- 7. The Renaissance Phase Two 2025 Replat; KPB File 2025-070  
McLane Consulting Group / Salamatof Native Association Inc.  
Location: South of the Junction Between Holt Lamplight Road &  
Escape Route  
Nikiski Area / Nikiski APC**

**ITEM #7 - PRELIMINARY PLAT  
THE RENAISSANCE PHASE TWO 2025 REPLAT**

<b>KPB File No.</b>	2025-070
<b>Plat Committee Meeting:</b>	May 27, 2025
<b>Applicant / Owner:</b>	Salamatof Native Association Inc. of Nikiski, Alaska
<b>Surveyor:</b>	Andrew Hamilton, McLane Consulting Inc.
<b>General Location:</b>	Holt Lamplight Area

THE RENAISSANCE PHASE TWO 2025 REPLAT  
REPLAT OF LOTS 1-5 BLOCK 6 AND LOTS 1-5 BLOCK 7 THE RENAISSANCE PHASE TWO (KN2020-65)

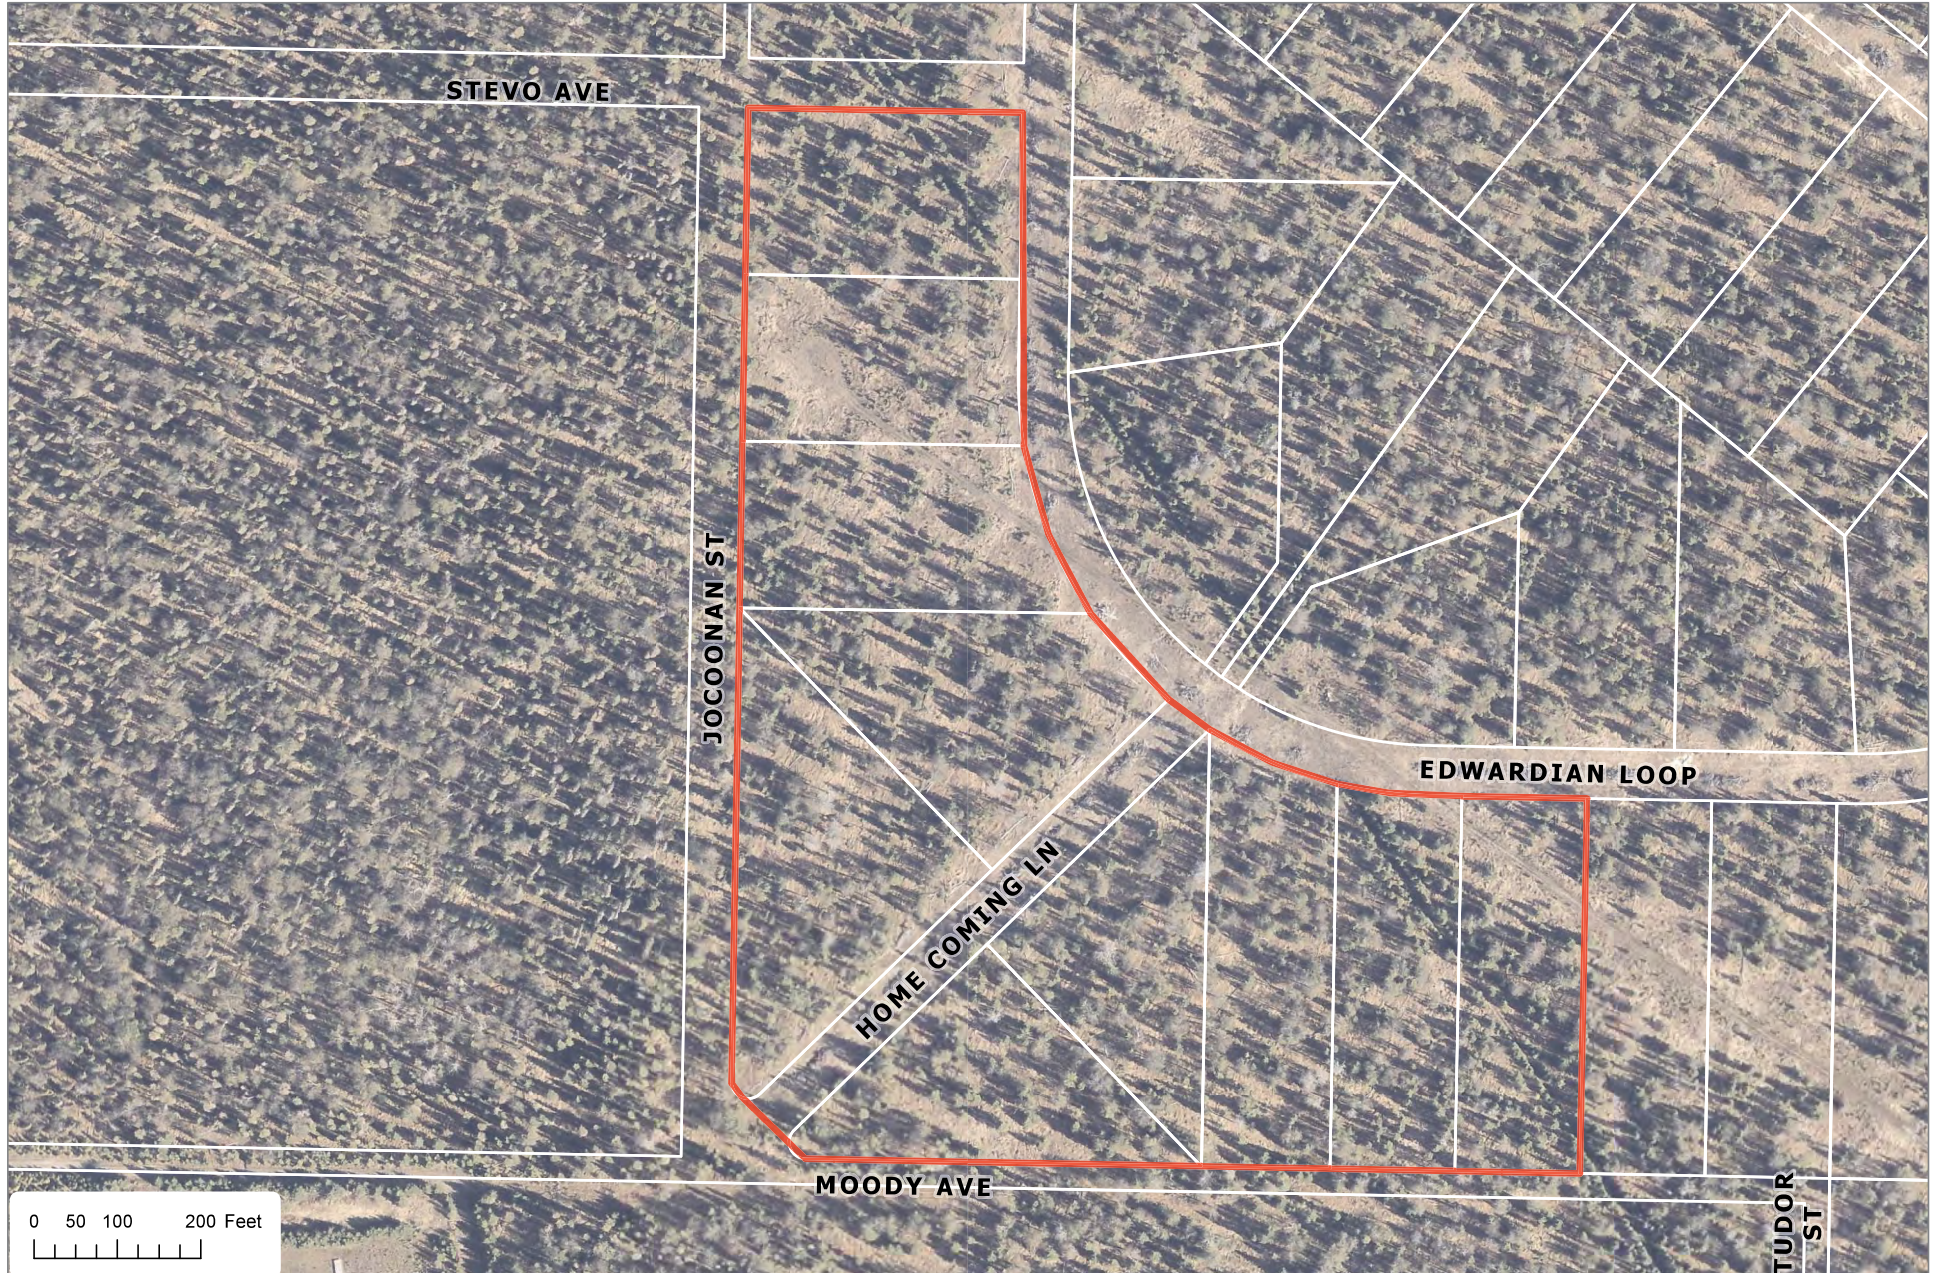
Several lots as follows 1A (next to 3A), 3A, 4A and 10A Block 6 and 6A and 7A Block 7 have double frontage on two roads and depths less than 250'. This is in conflict with KPB 20.30.230 – Lots-Double frontage prohibited when. When looking at the layout of the cul-de-sacs and the lots, it appears to be the best possible scenario for the plat layout. And the surveyor has requested an exception to KPB 20.30.200 – Lots – Minimum size to be discussed later. With the reduced size in the exception request, this layout again is reasonable. Staff recommends the Plat Committee concur an exception to KPB 20.30.230 Lots – Double Frontage Prohibited is not needed at this time and a note be added to the plat stating that main lot entry shall be from Lancelot Ct, Edwardian Loop, Home Coming Ln or Gwenevere Ct.

KPB Roads Dept RSA review	Out of Jurisdiction: No  Roads Director: Uhlin, Dil Comments: There are multiple lots on this plat that do not meet the borough minimum lot size, but no exception request.
SOA DOT comments	No Comments

Proposed Lots 1A through 5A, Block 6, Lot 7A and 11A, Block 6, Lots 4A and 5A, Block 7, and Lots 8A and 9A, Block 7, are less than the code minimum size of 40,000 square feet. The surveyor has submitted an exception request for KPB 20.30.200 – Lots- Minimum Size, that will be discussed later in the staff report.

There is a Soils Report on file for the parent subdivision; however, the new plat does not comply with the requirements of KPB 20.40.020- wastewater review not required, as it's increasing the number of developable lots. A soils report will be required and an engineer will sign the final plat. The surveyor has stated in the exception request that the proposed subdivision will be served by multiple community water wells and individual wastewater systems. Approval of the plat is needed to get the installation of the wells completed.

The parent plats granted a 15-foot-wide utility easement within the 20-foot building setback from all street rights-of-way and the entire setback within 5 feet of the side lot lines as a utility easement. The surveyor is granting a 15-foot utility easement on the proposed plat. **Staff recommends** the surveyor modify the typical detail on the preliminary plat to show 15-foot as notated in plat note number 4 and to label the sections of the utility easement granted by the parent plat per KPB 20.60.160 and sections of the easement granted by this plat.

- Modify Plat Approval date to May 27, 2025
- In Block 6, switch lot labels 1A and 2A to make a consecutive order counterclockwise around the cul-de-sac.
- CTP item #12 does not affect this property as noted on KN2014-51 at plat note 7 and can be removed from the CTP when updated.
- Show measured data on the drawing when field work complete.

- Modify KPB File No to KPB 2025-070
- modifying the legal description to "NE 1/4" to specify the subdivision location better.

- Remove the label for Range 12W
- Staff suggests adding a label for Edwardian Loop

- Please include names of dedicated rights-of-way
